REITZ & JENS, INC.
CONSULTING ENGINEERS

July 12, 2007

Trustees of Lake Tishomingo
C/O Ms. Clarue Holland
8625 Moran Place
St. Louis, MO 63114

Re: July 6, 2007 Site Visit

LAKE TISHIMINGO
SPILLWAY DETAILS

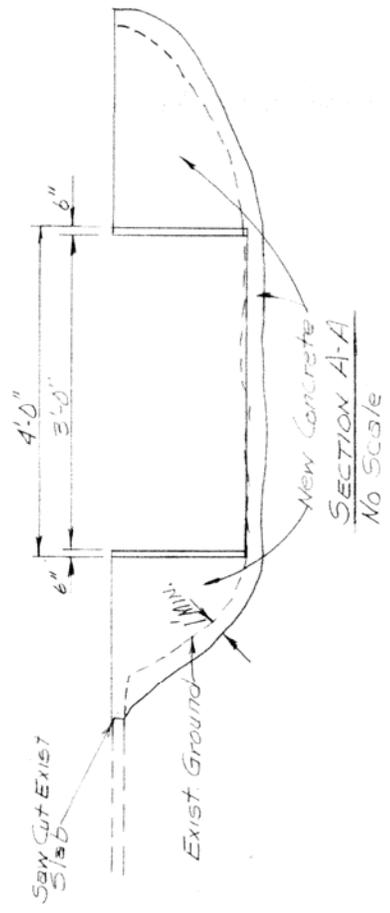
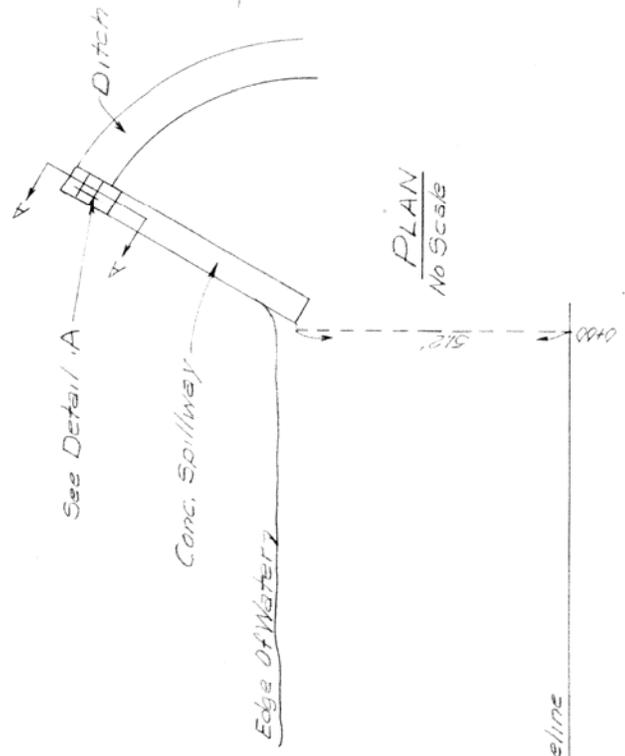
5. Siphon - It has been suggested that a permanent siphon be installed through the spillway, probably as a ready made means of lowering the lake when needed. I commented that it may be possible to lay the siphon in the spillway channel and concrete over it. It is my opinion that a 10 or 12 inch siphon pipe can be put in the narrow erosion channel without compromising the spillway capacity. It should be installed in a new trench within the first 100 feet \pm of the spillway, because of the relatively flat slope in that part of the spillway outlet channel.

If a siphon is installed, we recommend that a valved vacuum break port be included in the top of the siphon to assure that the siphon does not self-start during a flood event
